# BOARD DECISION NR 2008-02 NRCB Application No. 0701

Arclin Canada Ltd. Formaldehyde Production Plant, Sexsmith

September 2008

Figure 1: Arclin proposed Groundwater Monitoring Plan. Modified from Nichols Environmental Ltd., March 23, 2007, Proposed Groundwater Monitoring Program, Dynea Formaldehyde Resin Plant, Sexsmith, Alberta. Prepared for Dynea USA Inc., Moncure, NC.

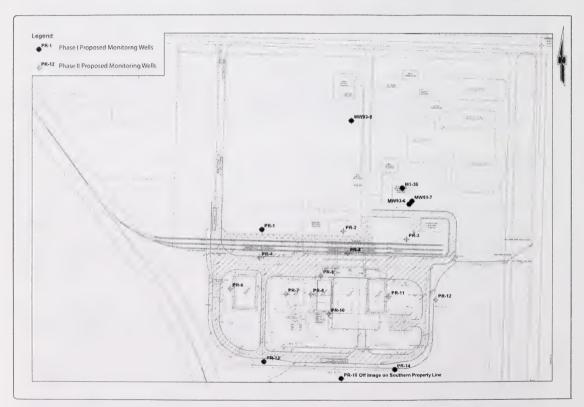
However, the Board notes that Phase II of Arclin's proposed monitoring plan provides for only two monitoring wells in close proximity to the formaldehyde plant, one located west and the other east of the plant. The Board also notes that there is some uncertainty about the

direction of shallow groundwater flow in the area and is concerned that the proposed monitoring wells near the formaldehyde plant may not be located appropriately to detect impacts to shallow groundwater, if such impacts were to occur. Consequently the Board requires as a condition that Arclin work with Alberta Environment to ensure that placement of any monitoring wells near the formaldehyde plant will be such that at least one monitoring well will be located down gradient of the plant and will be able to adequately detect any impacts on shallow groundwater that may originate from the plant.

Nevertheless, the Board is of the view that the groundwater monitoring program that Arclin has proposed as Phase II of its monitoring plan, which is designed to identify potential groundwater issues related to various operational aspects of the entire plant complex (including the formaldehyde plant) should be implemented.
